Vibration from Engine after Cold Soak

Service Category Engine/Hybrid System

Section Engine Mechanical

YEAR(S)	MODEL(S)	ADDITIONAL INFORMATION
2010 – 2011	Prius

Figure 1.

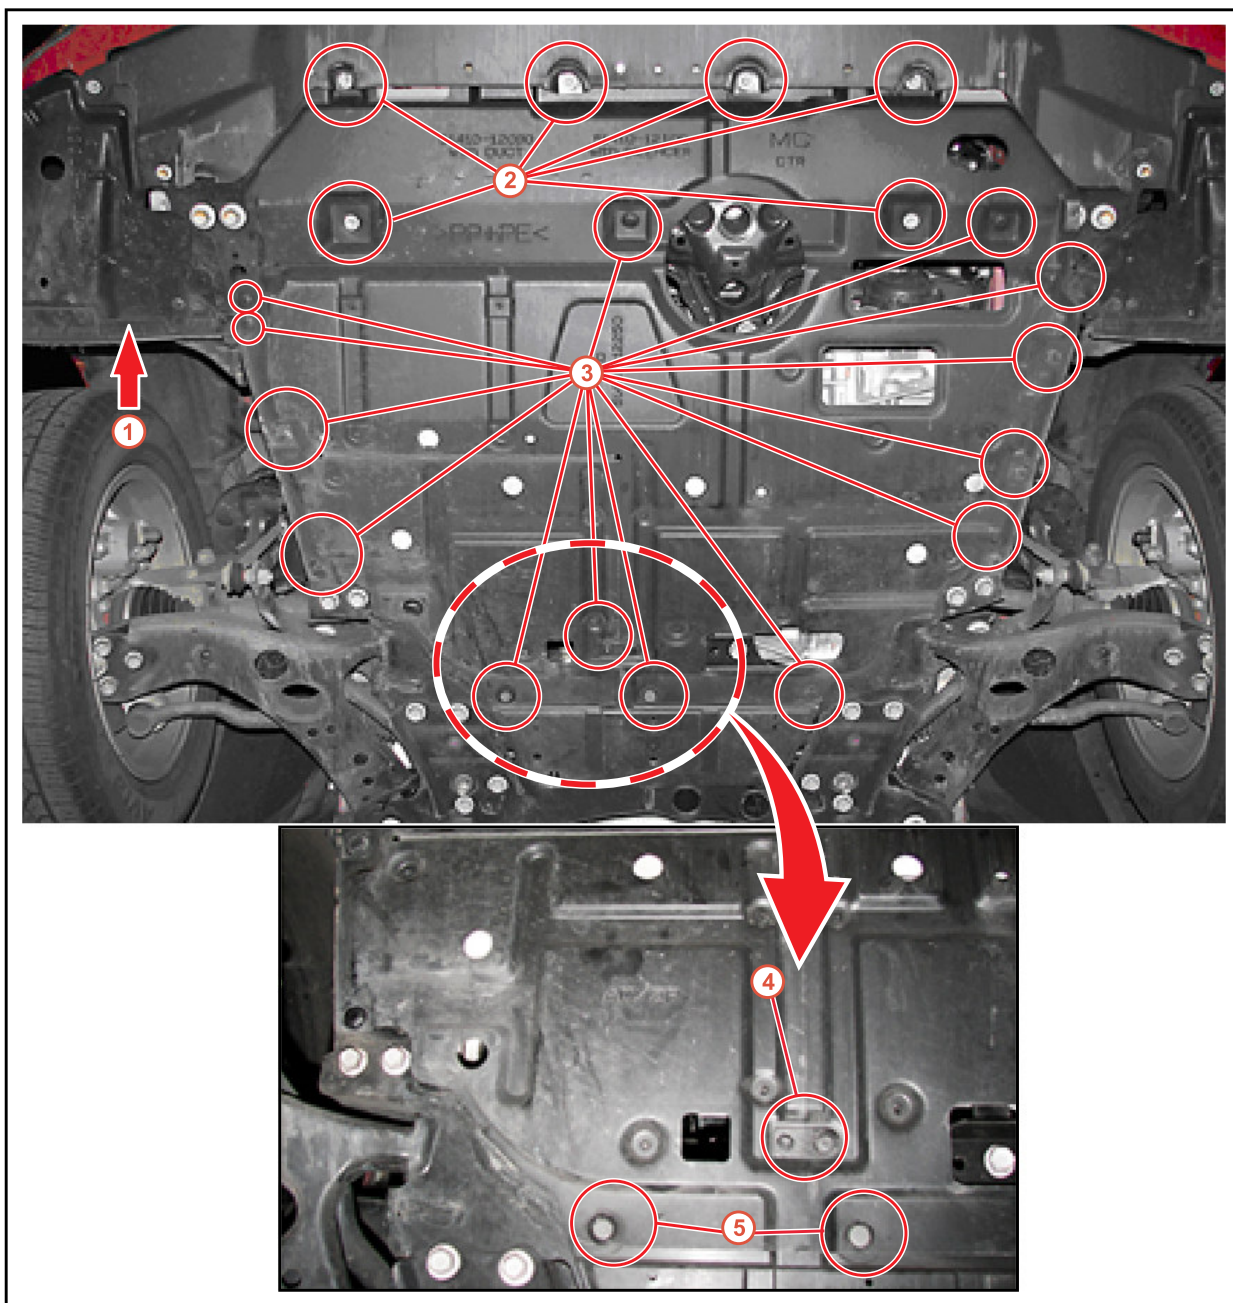
Remove the 6 bolts and 14 retaining clips from the engine under cover and slide toward rear of vehicle to remove cover.

There are three types of clips:

- 11 plastic to thin metal (Part No: 90467-07201)
- 2 plastic to thinner metal (Part No: 90467-09227)
- 1 plastic to plastic (Part No: 90467-07166)

Clips are not interchangeable. See Figure 1 for specific clip locations.

5. Reposition the engine under cover into place and install the 14 retaining clips in their correct locations, then install the 6 bolts (See Figure 1).

Figure 2.

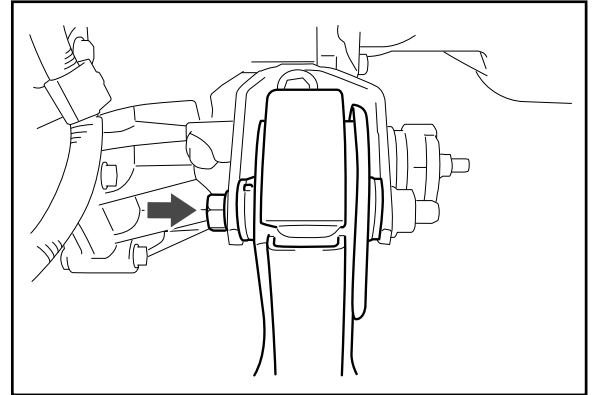
Some 2010 – 2011 model year Prius vehicles may experience an abnormal vibration or droning noise with the Internal Combustion Engine (ICE) ON after extended cold soak in extremely low temperature conditions until the engine bay begins to warm up. The right rear engine mount has been updated to address this condition.

3. Properly support the engine assembly with a jack and remove the two bolts from the right rear engine mount.
4. Install the new rear engine mount and properly torque bolts.

Torque: 95 N*m (969 kgf*cm, 70 ft*lbf)
